Comment To Propose Increasing Number Of Taps Of Reference Equalizer In TDECQ Measurement For P802.3bs D3.4

20171003

Example 1 - TDECQ vs Number of Taps

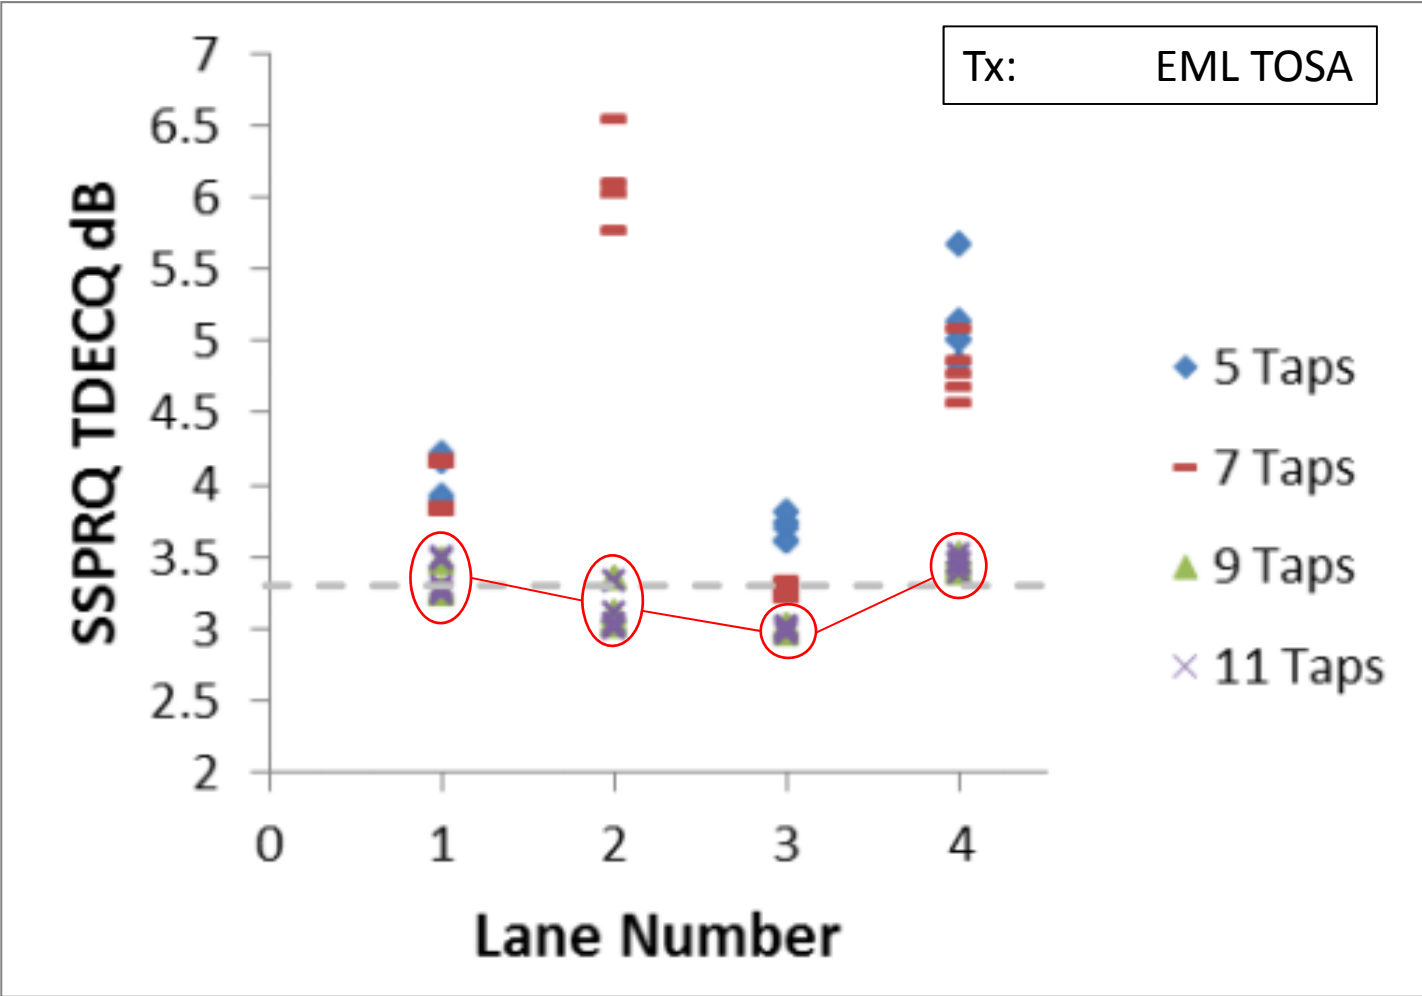
Observation:
• 9 T-spaced taps greatly improves the SSPRQ TDECQ results.

Increase taps to 9T

Example 1 - SSPRQ vs PRBS15

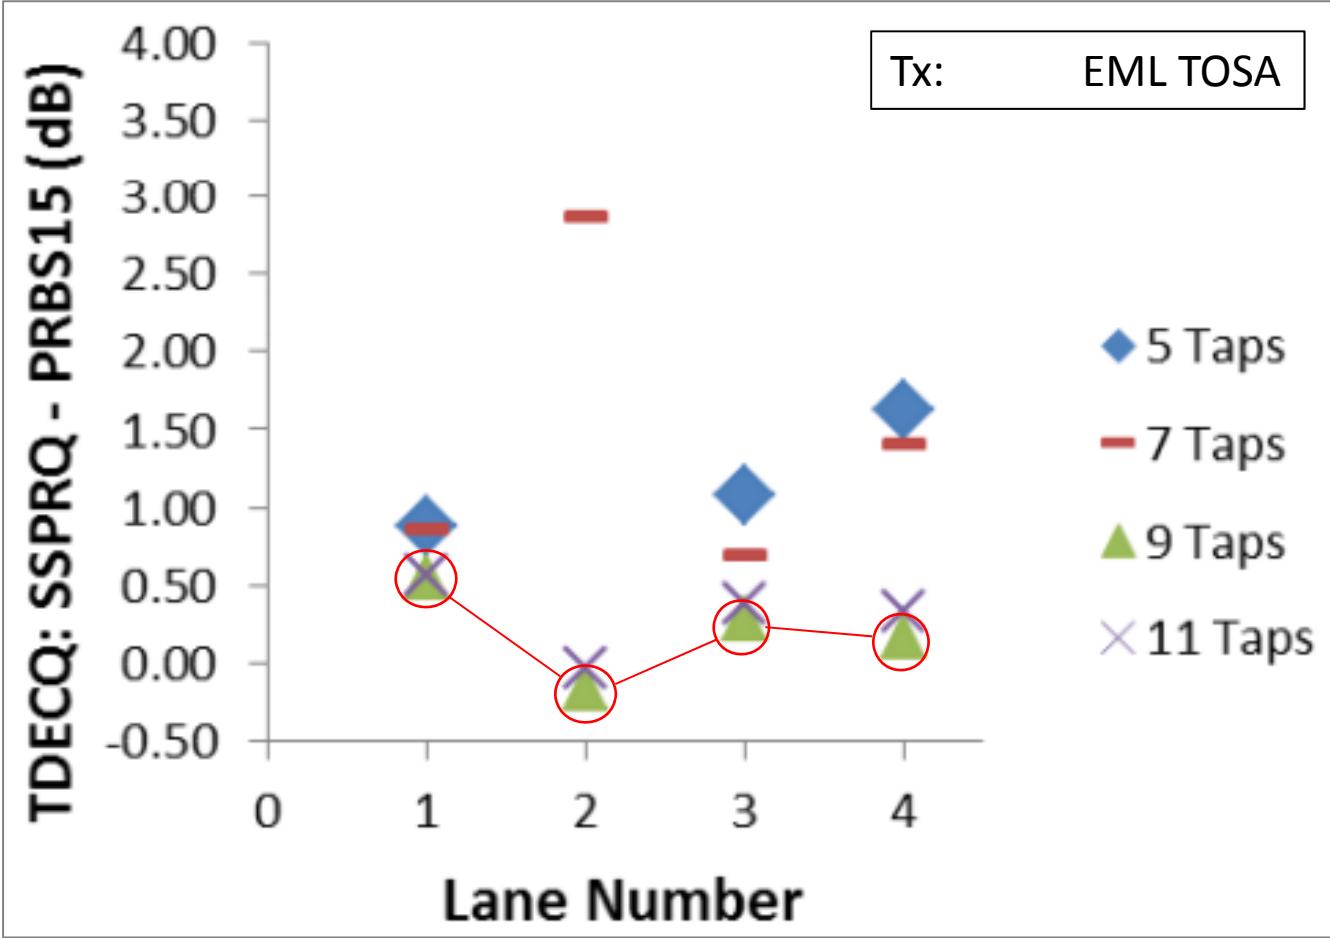
- With 9 tap, T-spaced FFE, $TDECQ_{SSPRQ} - TDECQ_{PRBS15} \sim +0.5 \text{ dB}$.

Example 2 - TDECQ vs Number of Taps

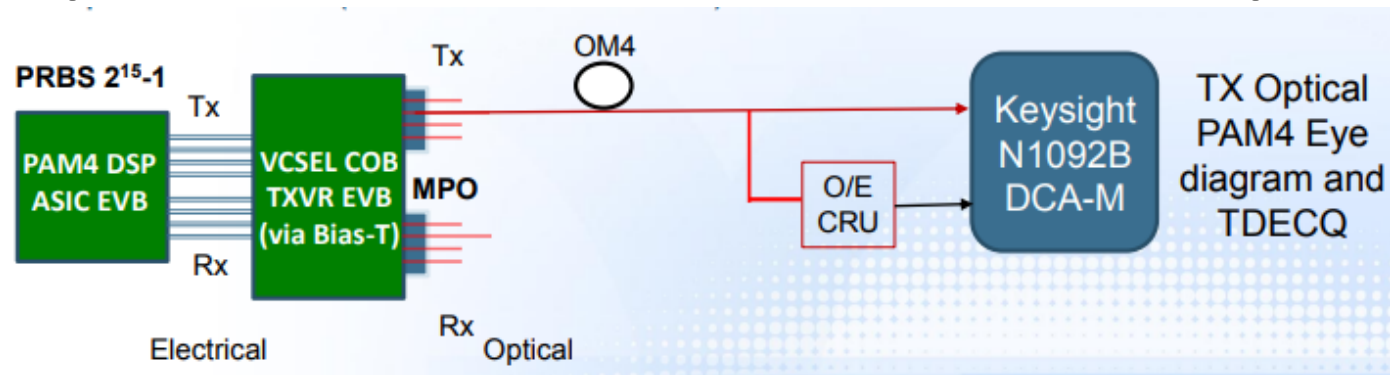
- TDECQ measurement less stable at 5T.
- Only 9T measurement satisfied TDECQ (max) of 4.9 dB at specified filter bandwidth.
- PRBS15 used (SSPRQ unavailable) → Expect to not pass if SSPRQ increases TDECQ by +0.5 dB.

Increase taps to 9T

Example 3 - SSPRQ vs PRBS15

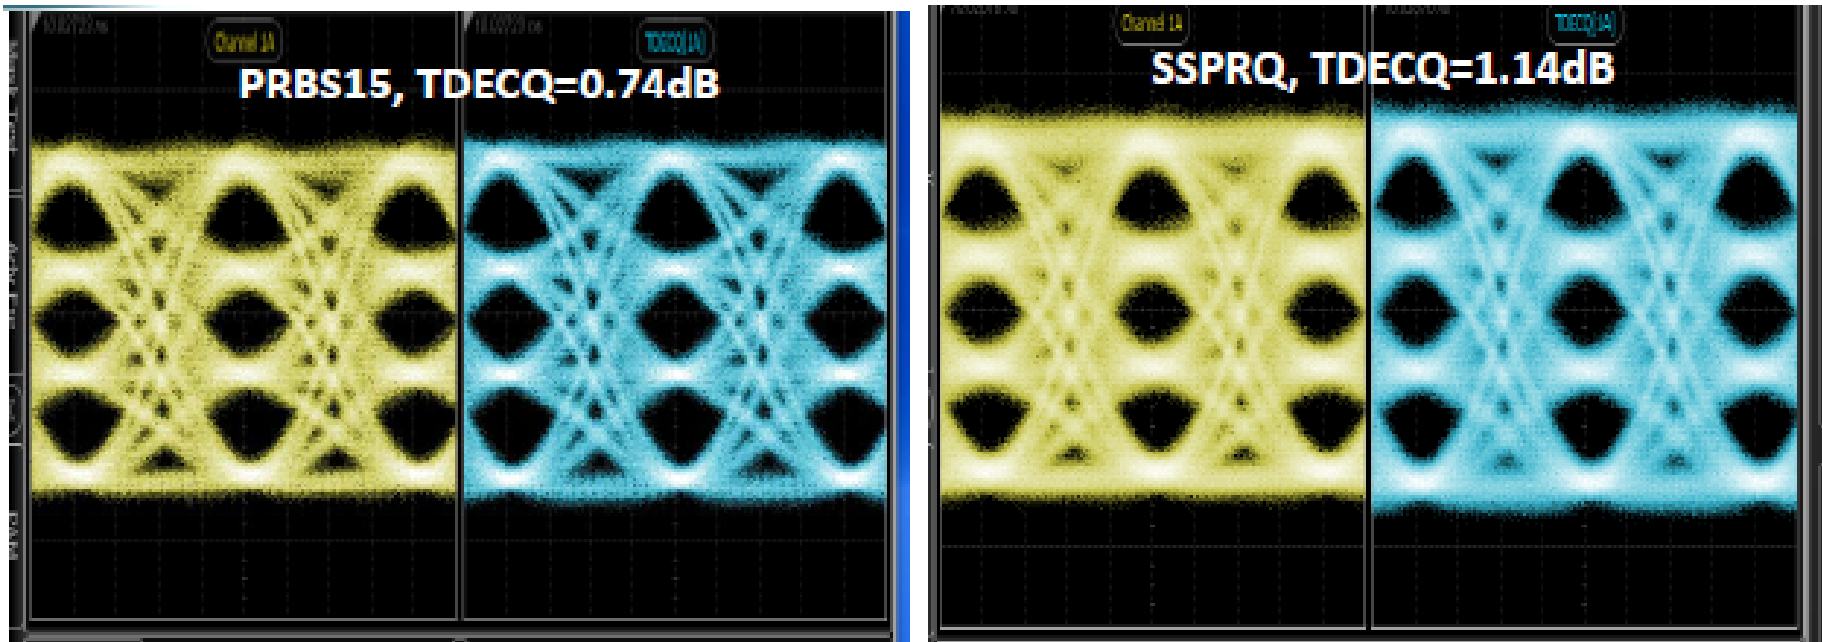
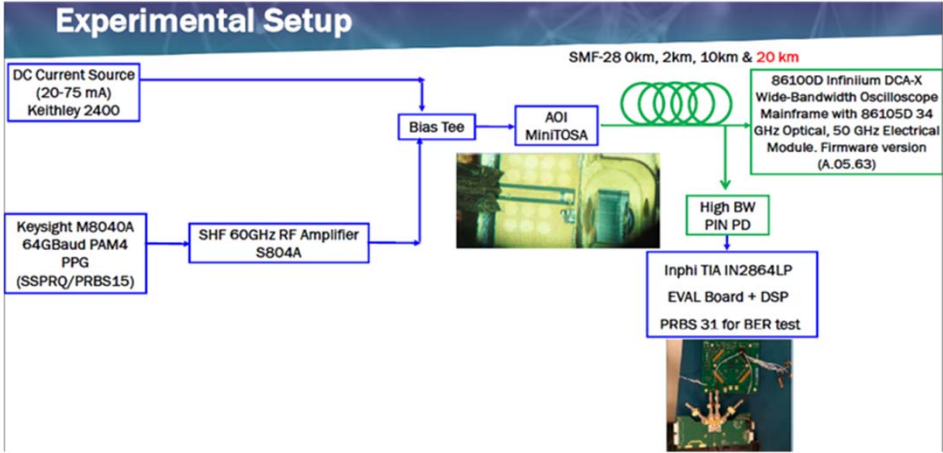
- $TDECQ_{SSPRQ} - TDECQ_{PRBS15} \sim +0.5 \text{ dB (max)}$.

Example 4 - SSPRQ vs PRBS15

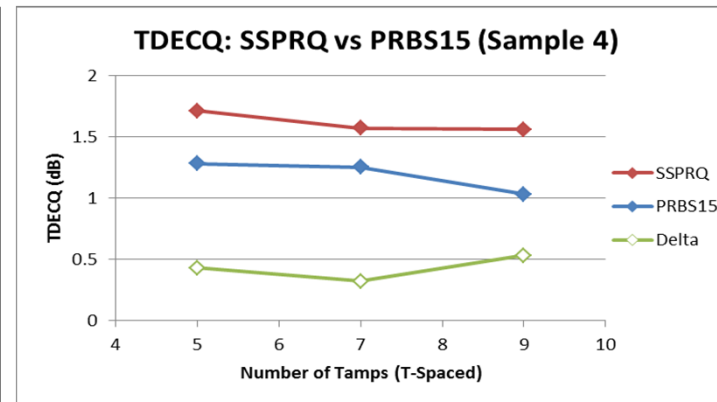
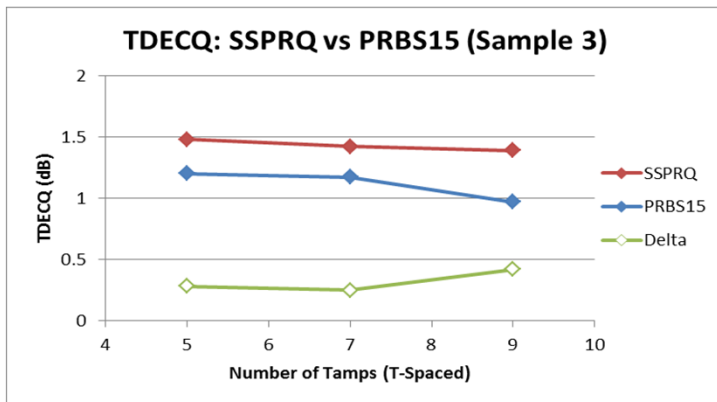
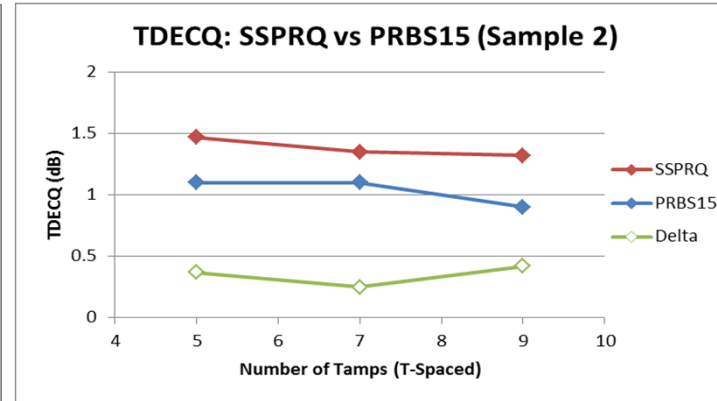
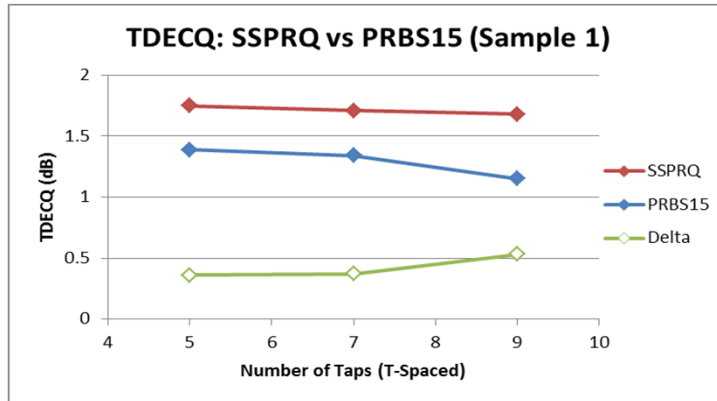
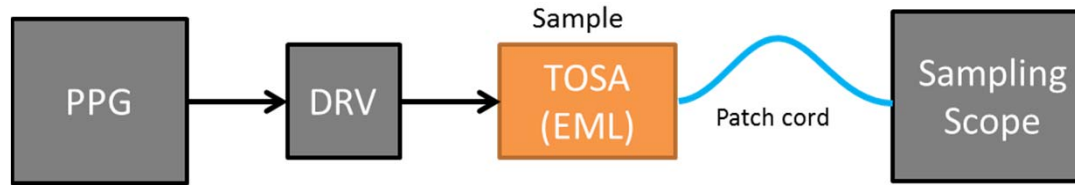
- $TDECQ_{SSPRQ} - TDECQ_{PRBS15}$ in range of +0.25 to +0.53 dB for 5T to 9T FFEs.

Example 4 - TDECQ vs Number Of Taps

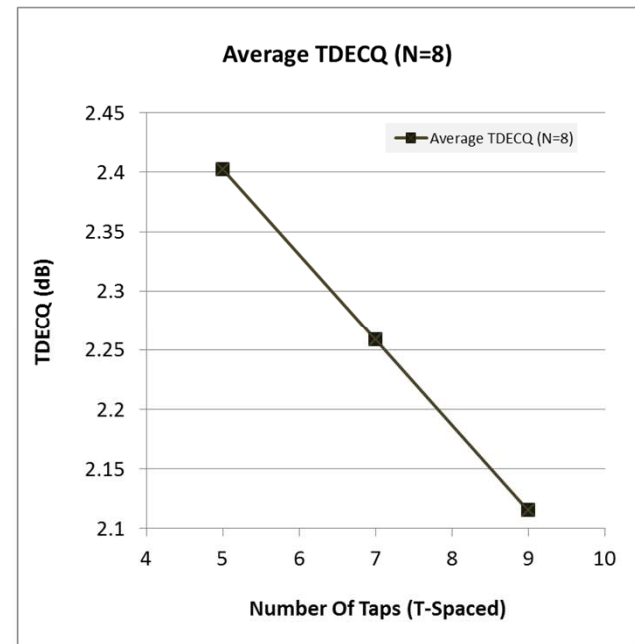
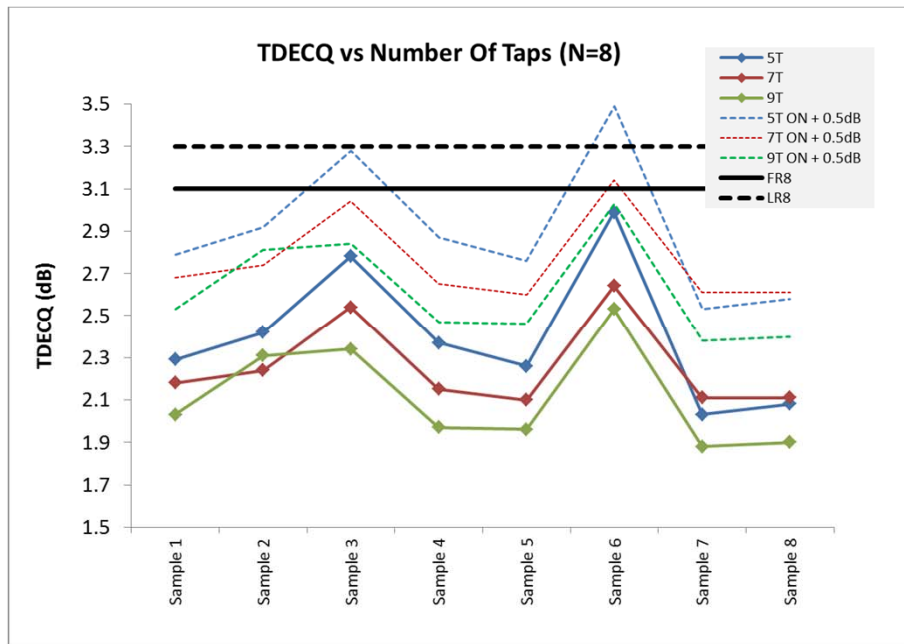
1. TDECQ decreases with number of taps.
2. For 5T, if +0.5 dB correction used to convert from PRBS15 to SSPRQ, samples exceeding TDECQ (max) are 2/8 for FR8 and 1/8 for LR8.
3. For 9T, 100% pass for FR8 and LR8, even after +0.5 dB correction to TDECQ.

Increase taps
to 9T
